**Submission in regards to amended DA2022/1211 Development Application
23 Lancaster Crescent, Collaroy**

“Demolition works and construction of a dwelling house including swimming pool.”

Corona Projects has been engaged by the property owners of 25 Lancaster Crescent to undertake an assessment of the revised architectural drawings submitted under DA2022/1211 and provide a submission to Council on their behalf. 25 Lancaster Crescent lies to the west of the development site at 23 Lancaster Crescent. This assessment is based on a review of the amended development application plans and documents available for inspection on Northern Beaches Council’s website uploaded on the DA tracker on 27 February 2023.

Figure 2 – Viewing Location Diagram (Corona Projects, 2022)

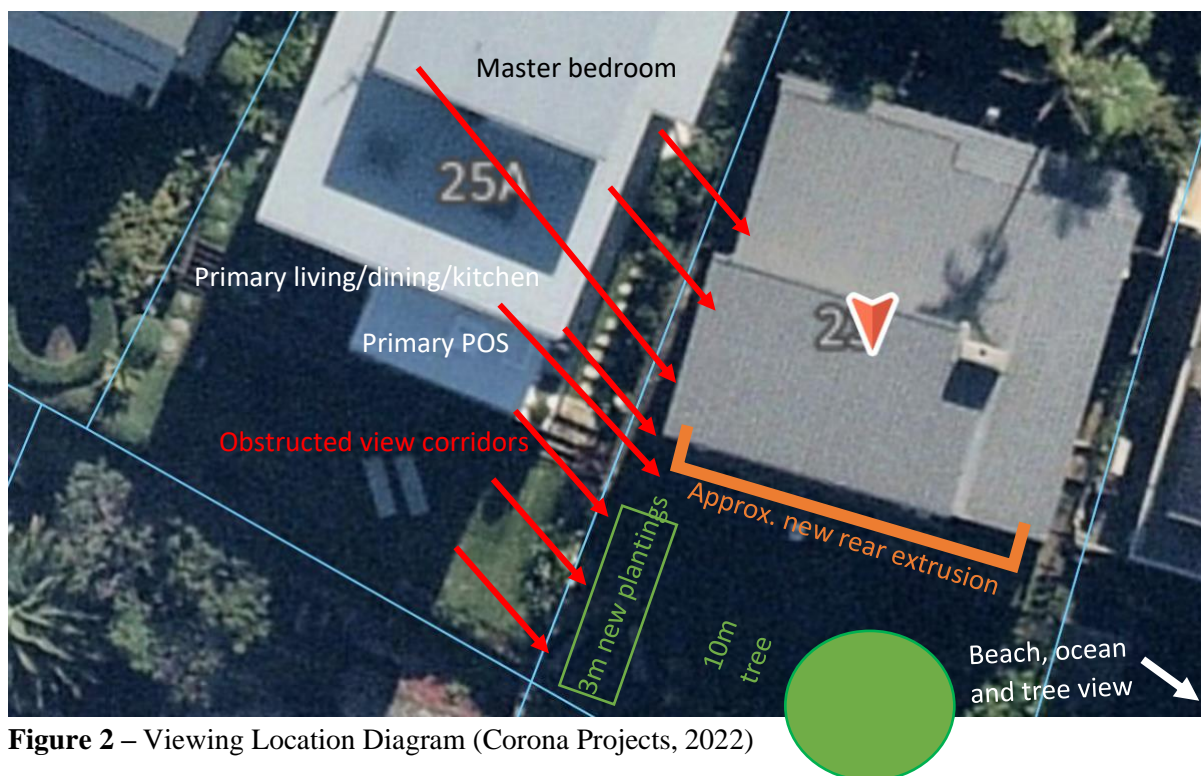
As detailed in figure 2, the new upper floor at 23 will still obstruct significant views from the existing upper floor of 25, and the rear extrusion on the ground and lower ground floors of 23 will obstruct significant views from the ground and lower ground floors of 25. New 3m and 10m high plantings will also obstruct views for No. 25 when mature. The proposed 10m *Livistona Australis* (Cabbage Tree Palm) tree will be of particular obstruction, given its bulky and obtrusive appearance when mature as shown in figure 11 which is not in keeping with the style of existing plantings in the rear gardens of adjoining sites. **Appendix A** shows the existing and proposed views in greater detail, and highlights the public loss of view from the public domain along Lancaster Crescent.

It is evident that the significant changes proposed under DA2022/1211 as amended will impact on the view of 25, displaying no form of view sharing. This is in contrary to the opinion contained in the Statement of Environmental Effects that “the proposal provides for no view loss from surrounding properties.” (page 8).

- a) **Action:** Prepare 3D view loss analysis modelling to accurately depict the extent of view obstruction, and do not allow any envelope that will obstruct the water/headland/landscape/beach view for 25 Lancaster Crescent.
Outcome: To better analyse and understand the impact of proposal and to modify the design, if required to protect the amenity of 25 Lancaster Crescent.

Figure 4 – Established upper floor rear setback, a star indicating which sites have a first floor (NearMaps, 2023)

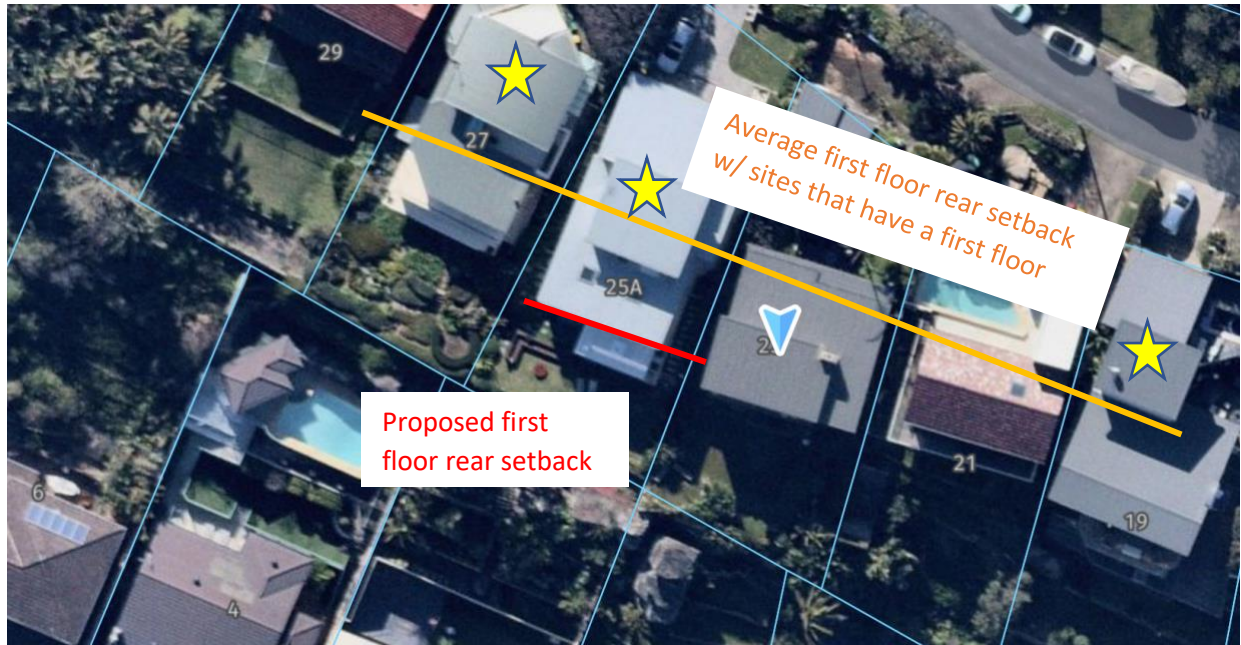
Figure 3 shows the existing established lower ground and ground floor rear setbacks which the existing dwelling at 23 Lancaster Crescent contributes to, whilst figure 4 shows the average first floor (third storey) rear building line using 19, 25 and 27 as guides as these sites feature three floors. The proposed works under DA2022/1211 even as amended will be entirely out of character and alignment with these established buildings lines and will subsequently impose adverse amenity impacts for its neighbours .

- c) **Action:** Increase the new upper floor setback to align with 25 Lancaster Crescent, and increase the ground floor and lower ground floor setbacks to align with the existing building at 23 Lancaster Crescent, or greater to comply with the recommendations (a) and (b).
Outcome: This will reduce overshadowing, visual bulk, view obstruction and the obstruction of the access hole between 23 and 25.

Figure 5 – Access chamber diagram, with the access area circled in green (Olsen Infrastructure, 2021)

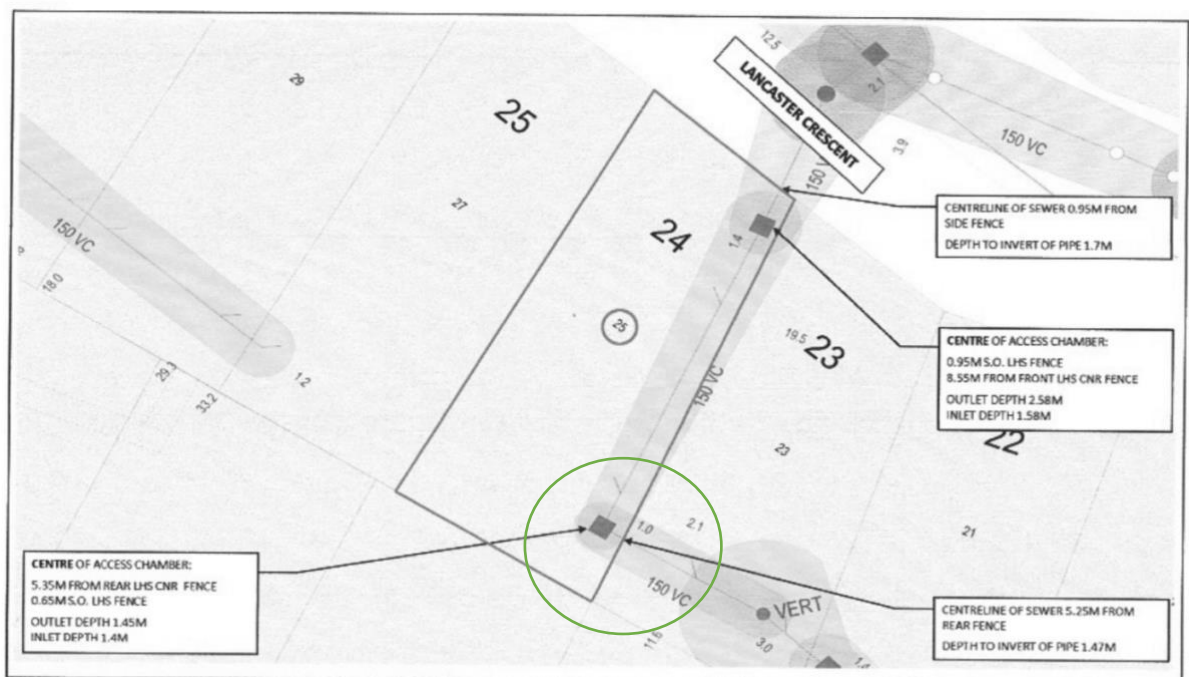
The extent of rear extrusion is also likely to impact upon the function of a Sydney Water manhole, located along the shared boundary of 23 and 25 Lancaster Crescent, highlighted in Figure 5.
